December 10, 2008

Project No: 0308-006-01

**RE: NWB 3BM-ARC0810 ARCTIC BAY SEWAGE LAGOON WATER LICENSE  
AMENDMENT –GEOTECHNICAL AND GEOTHERMAL REVIEW**

**Figure 1. Sketch of Thermistor String in Key Trench Detail (not to scale, meant for illustrative purposes only).**

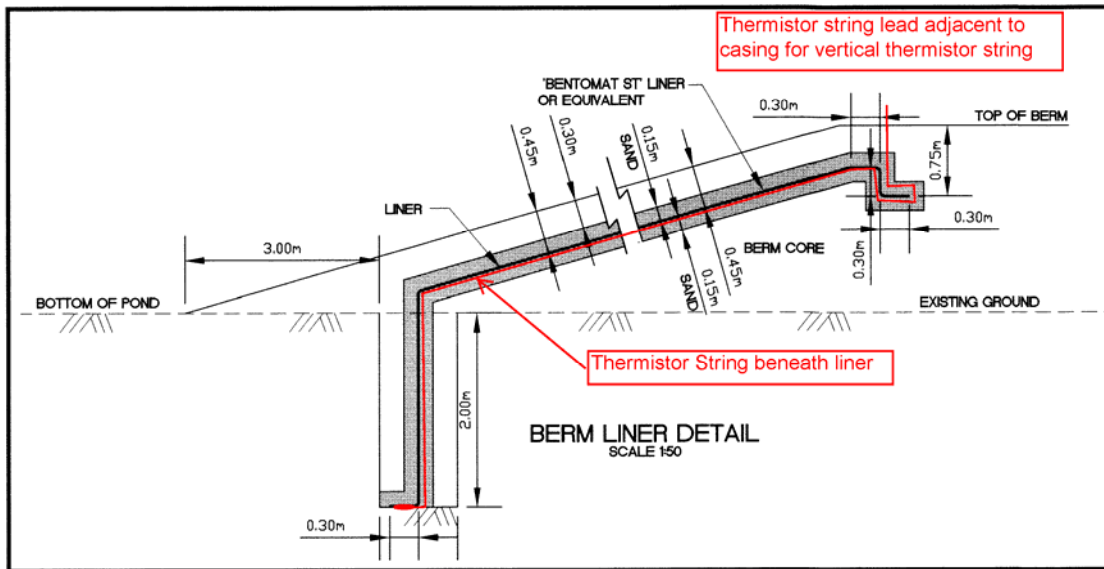
Issues (c), (d), and (f) were not addressed by the Designers. BGC requests that the Designers explain why the location of the liner key trench differs from that recommended from the geothermal analyses.

The Designers indicated that they are not opposed to the installation of thermistors within the key trench, provided that they are installed in a manner that does not compromise the integrity of the liner. Below is a sketch illustrating how BGC thinks that this could be done. This should be done for each station where there is a vertical thermistor string.
